Bridge Preliminary Design Report

**Ramp C over Fairground Road
Bridge No. SCI-823-1595**

**SCI-823-10.13
PID No. 79977**

- ODOT Review Comments to Structure Type Study with Consultant Responses

BEAR AND FORWARD ABUTMENT SECTION

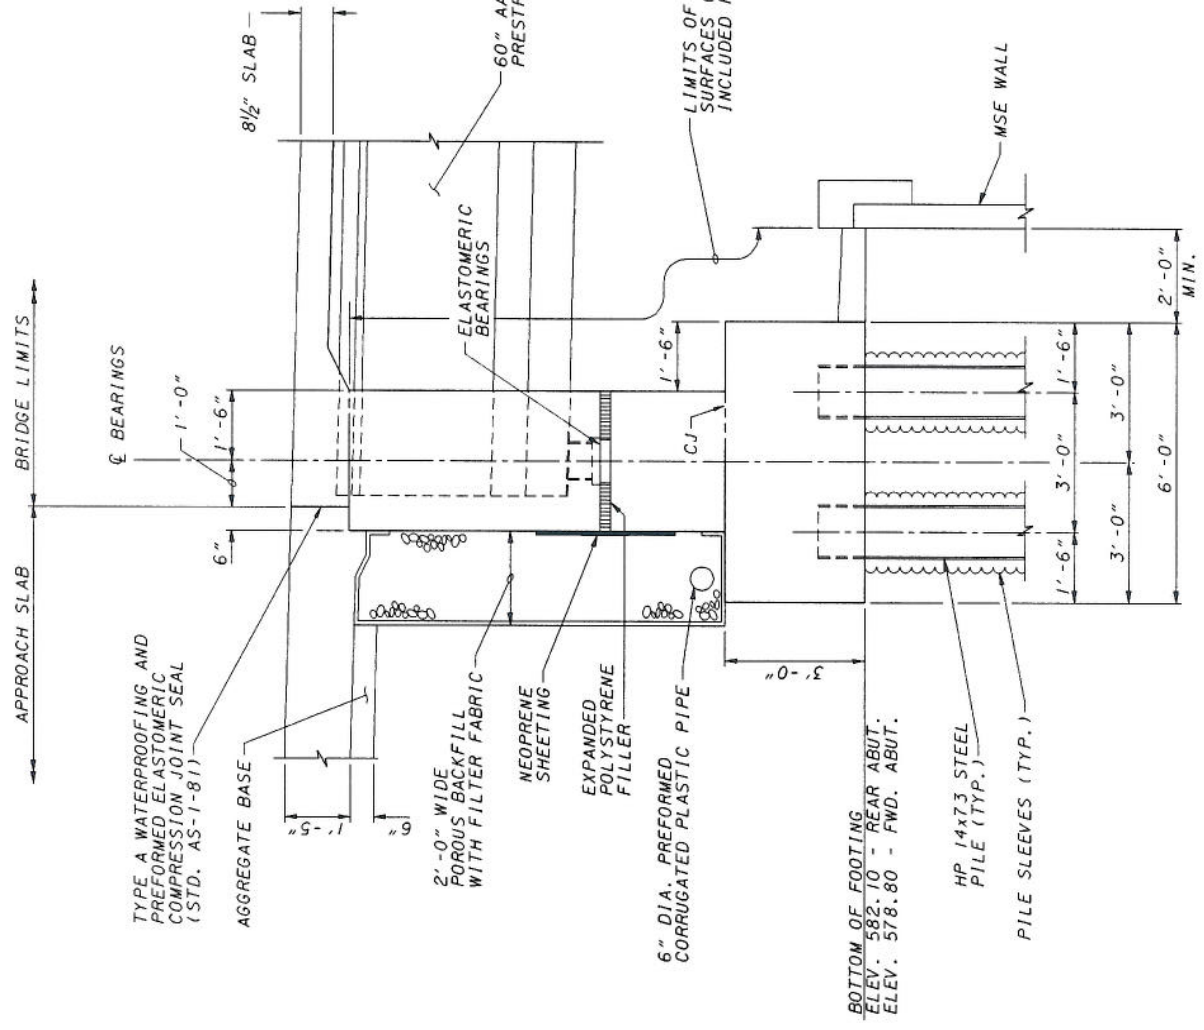
1. Wall 1 & 2: Sheet 12 of 30 of the Retaining Wall Plans dated 8-07 shows cross sections of the abutments. These indicate approximately 10-ft of fill from the bottom of the abutment pile cap to the bottom of the approach slab. Assuming the construction sequence is to build the MSE wall, drive piles through hollow cans, fill the cans with sand, construct the abutment, and then place the ten feet of fill to bottom of the approach slab, and no surcharge load is to be placed, then evaluations of the following should be considered:

2. Rear Abutment Section - Ramp B (Sheet 3 of 3): See comment 1 above.
3. Forward Abutment Section - Ramp B (Sheet 3 of 3): The approach embankment and end slope are approximately 30-ft in height. Since this height of fill is nearly the same as MSE Wall 2, this approach embankment and end slope will likely be constructed in stages. Assuming the construction sequence is to build the embankment in stages, drive piles through hollow cans, fill the cans with sand, construct the abutment, and then place the ten feet of fill to bottom of the approach slab, and no surcharge load is to be

- a. Bending Stresses in the Battered Piling: The plans show a front row of battered piles. The downward movement of the soil will induce bending in the piles. The magnitude of stress and impact on the performance of these piles will need to be considered.
 - b. This settlement will occur in the soils below the cans. Therefore, downdrag will need to be considered in the portion of the piles below the cans.
 - c. If straps are to be placed on the abutment backwall for lateral restraint of the backfill soils, the primary and long term secondary settlement could pull the straps downward and cause possible rotation of the backwall, structural distress, and/or break the strap connections.
 - d. Impact of primary and long term secondary settlement on the approach slab.
4. Ramp C: Please see comments 1-3 above.

Figure 1 - Soil Profile for MSE Wall 2

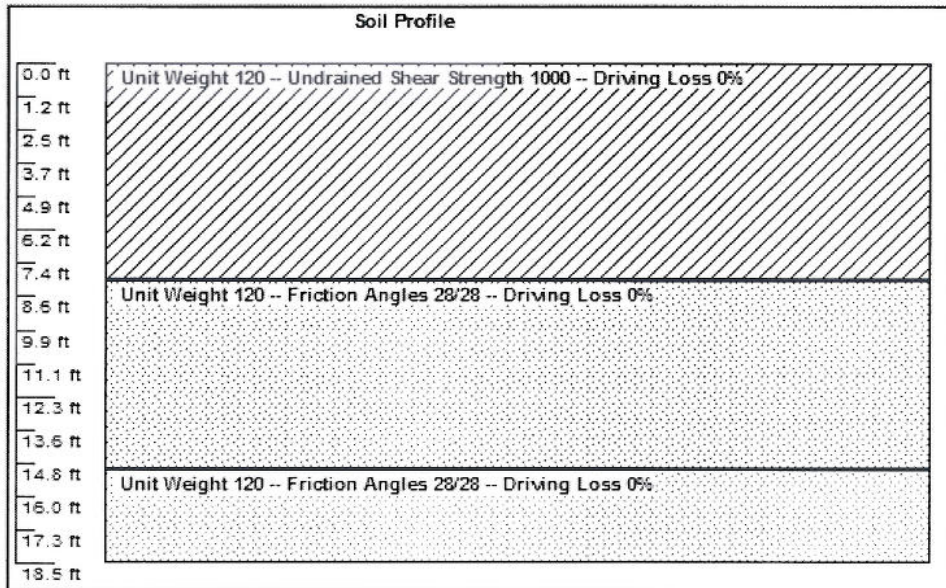
1. MSE Wall 2: The DLZ design computations in Appendix IV, page 1 of 21, show a geotechnical design profile as follows:
 - a. Ground surface of the boring (elevation 566-ft) to elevation 548-ft (18-ft below ground surface) is a silty clayey material with an undrained shear strength of $C = 1,500$ psf.
 - b. From elevation 548-ft down to elevation 544-ft (22-ft below ground surface) is a sandy material.
 - c. Top of Rock is encountered at elevation 544 (22-ft below the ground surface).
 - d. Water Table is encountered at elevation 550-ft = 16-ft below ground surface.

However, all the MSE Wall 2 borings show a predominately loose sand (79% sand and gravel) with an estimated friction angle of approximately 28-degree (based on N value corrected for overburden) at a depth of approximately 8-ft (elevation 558-ft). This layer extends down an additional 7-ft to elevation 551-ft. The "sand and gravel" layer encountered is a very loose to loose sandy gravel, also with an estimated friction angle of approximately 28-degrees. This layer extends to the top of rock (elevation 544-ft).

I would recommend re-evaluation of the borings for MSE Wall 2, and performing slope stability analysis using the profile depicted below in Figure 1. In particular, I recommend replacing the friction angle of the gravel sand at the rock interface with a more appropriate value of 28-degrees.

With these considerations in mind, I recommend that the MSE Wall 2 location be over-excavated an additional 2.5-ft from what has been proposed, and backfilled with MSE backfill grade material. The proposed scheme has the bottom of the leveling pad at elevation 560.5 (5.5-ft below grade). Granular soil is at approximately elevation 558-ft or an additional 2.5-ft. See comment 1. In addition, the water table is well below this excavation. Advantages include:

SITE PLAN
 SCIO COUNTY
 STA. 3891+89.99
 TO STA. 3892+96.87
 SKT
 DGS
 JBA
 SCJ
 08/07
 DATE

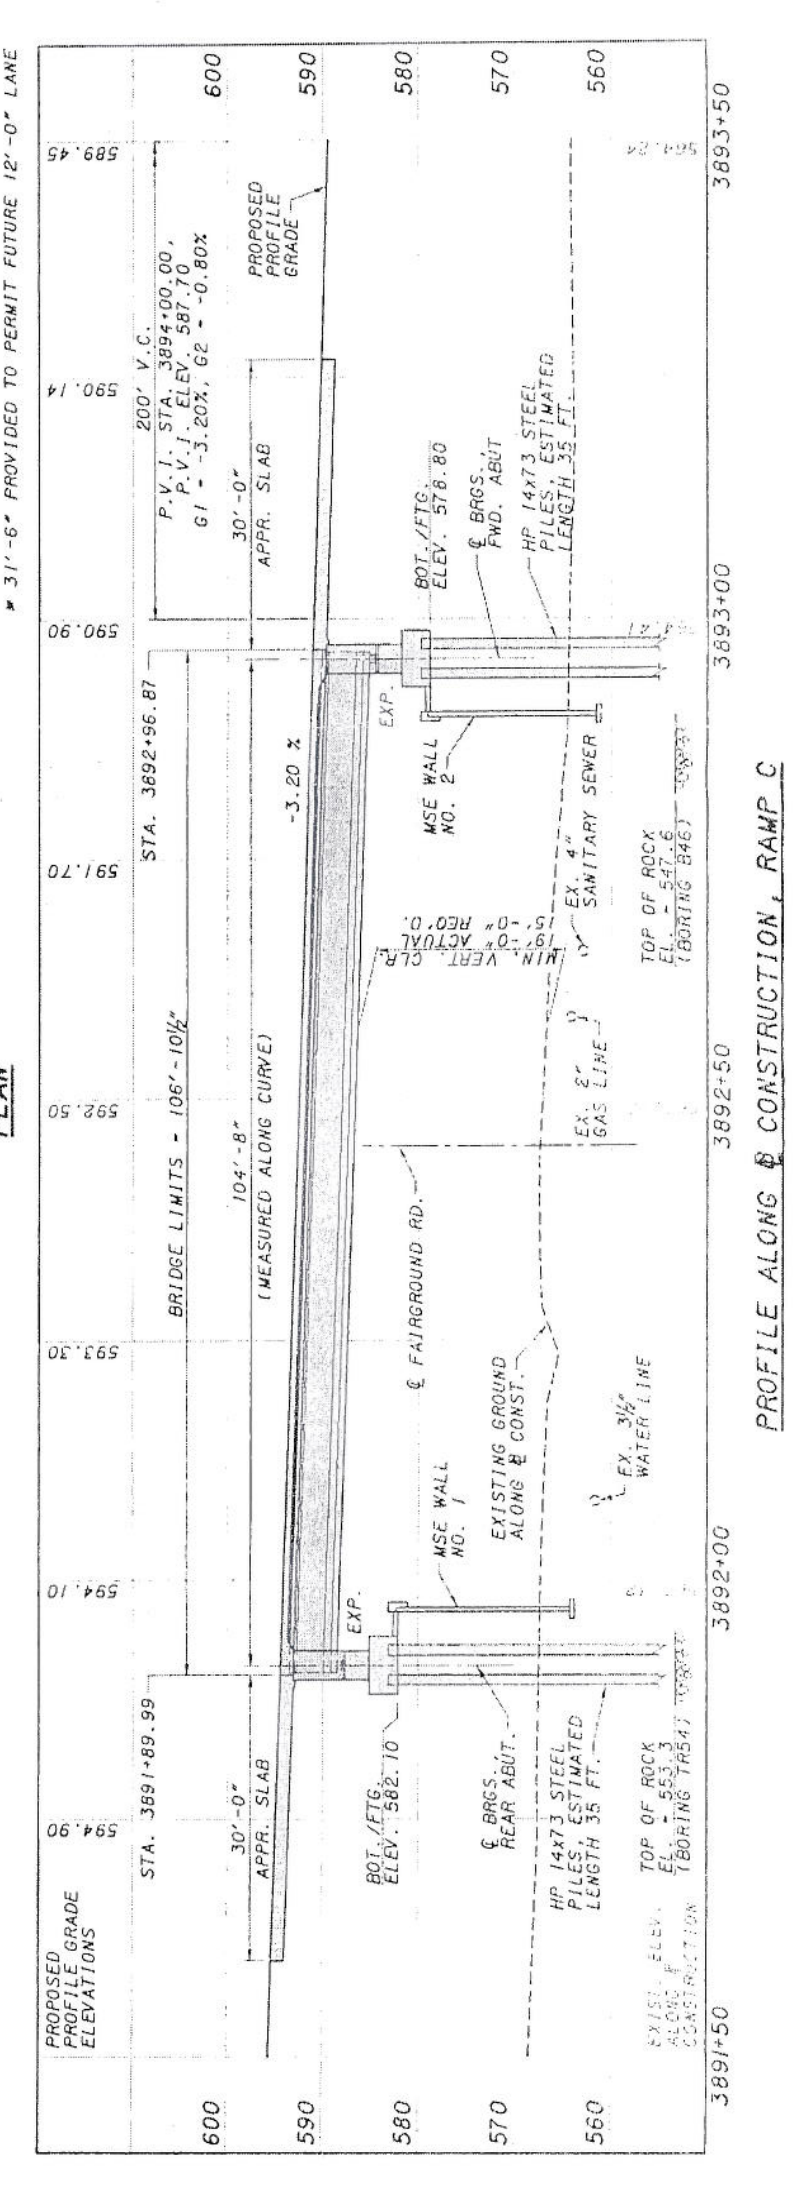
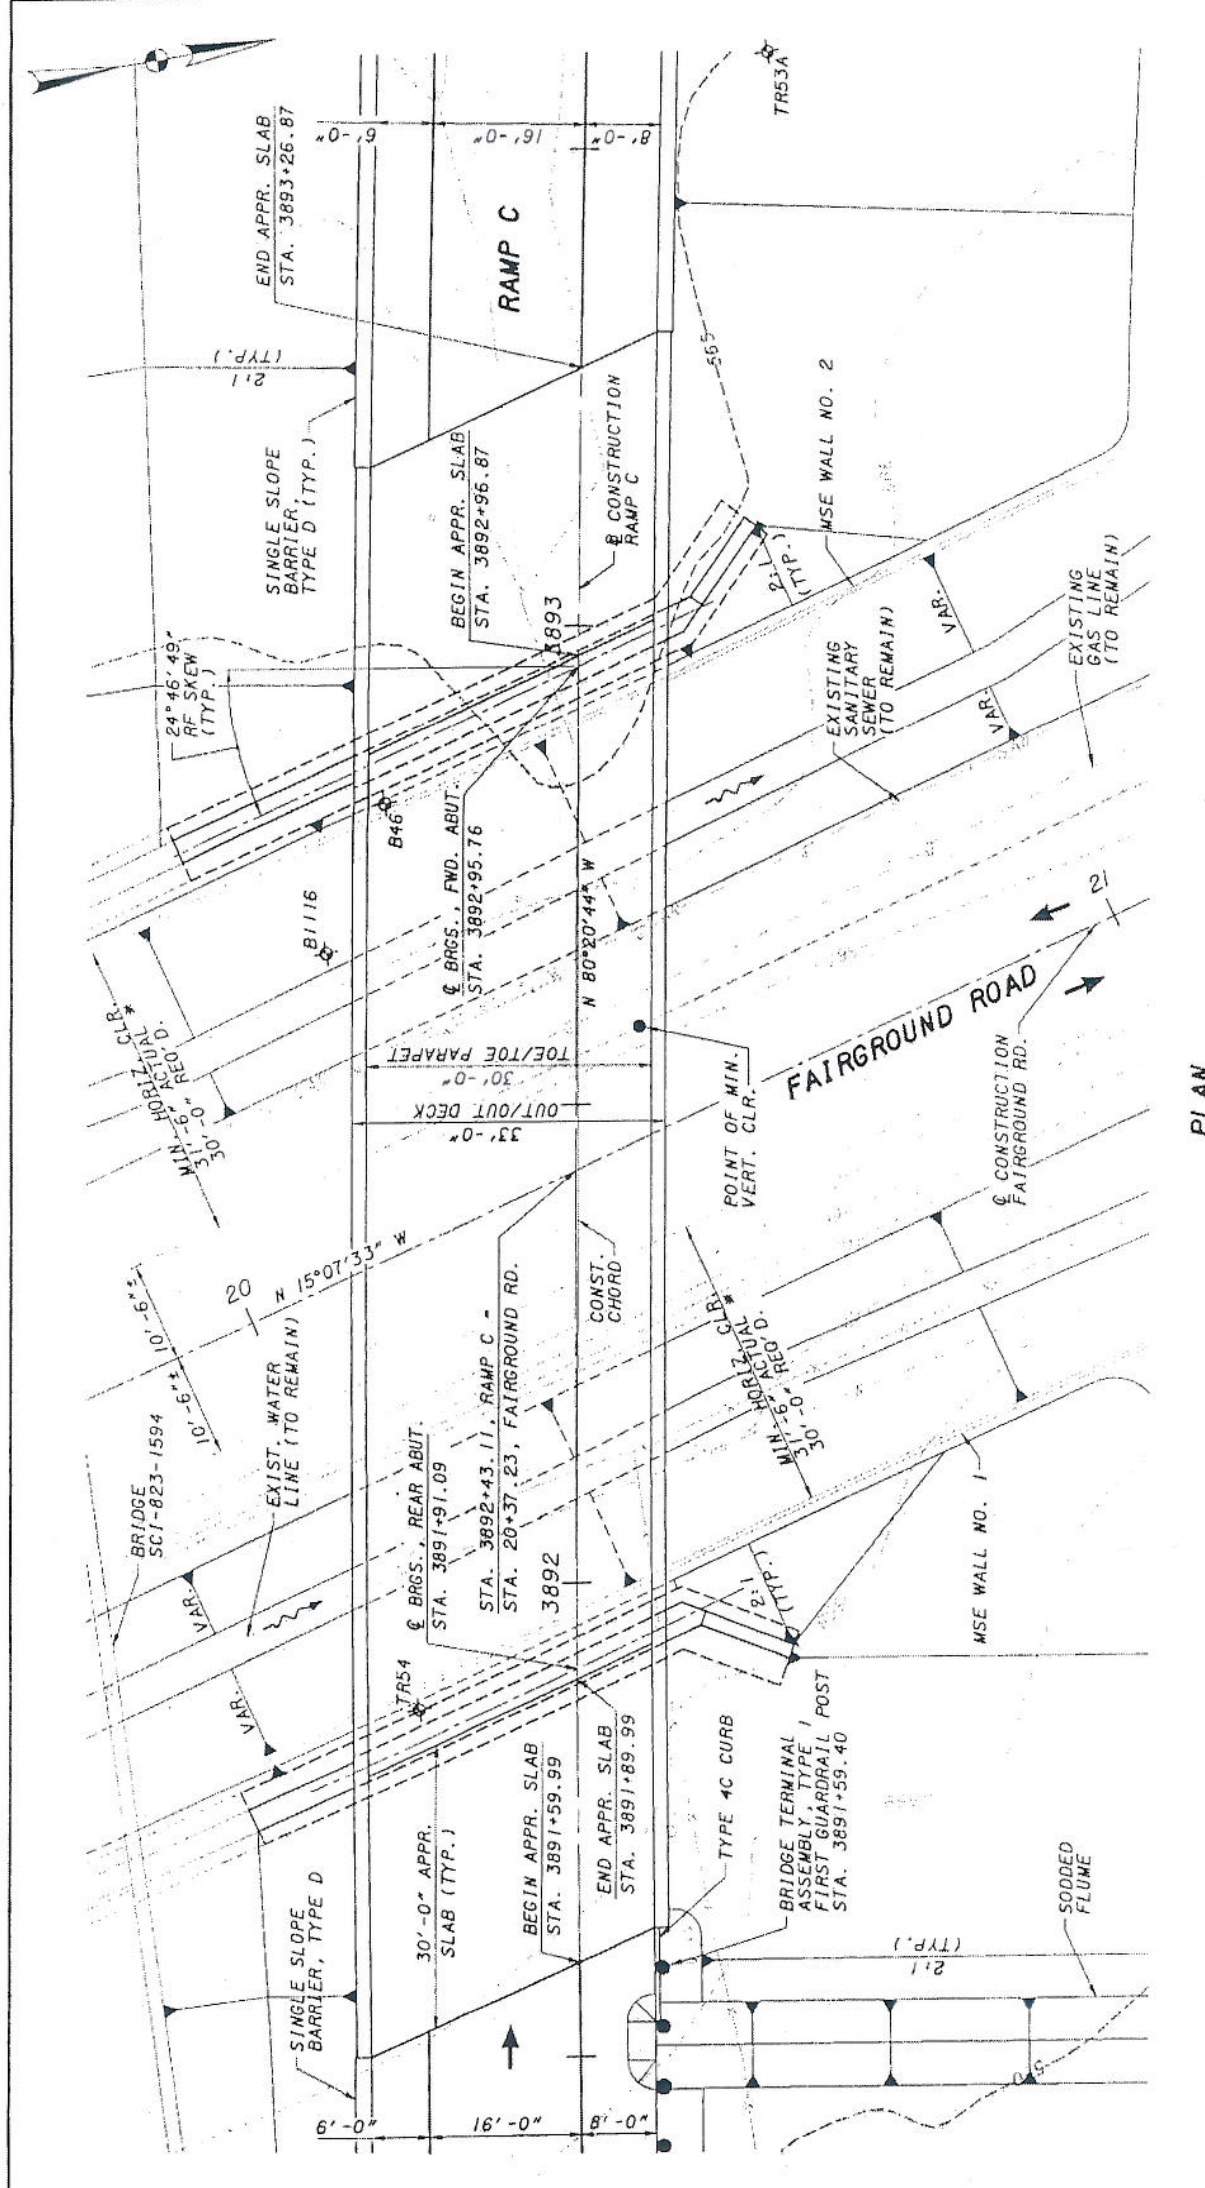
<p>Site Plan (1/3)</p>	<p>5. We could not verify the 30'-0" proposed horizontal clearance after referring to ODOT's L&D Manual, Volume 1, Fig. 600-1. Please make sure that approval of horizontal clearance is obtained from ODOT - Office of Roadway Engineering Services prior to proceeding.</p>	<p>See attached documentation pertaining to design/posted speed and design year ADT along Fairground Road to justify the required 30'-0" clear zone distance to the MSE walls. Since the PAVR submittal, CH2M HILL has had discussions with the Scioto County Engineer's Office. The county stated that Fairground Road will be improved to 2-12' lanes and that the speed limit is 55 mph. With a design speed of 60 mph and an ADT greater than 3000 vpd, Fig 600-1E recommends a clear zone distance of 30'-0" when the ditch foreslope varies between 6:1 to 4:1. Due to additional culverts being added along Fairground Road, new ditches are being designed with foreslopes varying from 6:1 to 4:1; the steeper than 6:1 foreslope also provides the avoidance of utilities, while also using existing drainage structures. Providing lateral bridge clearance equal to the clear zone provides a safer roadway and allows for future improvements.</p>
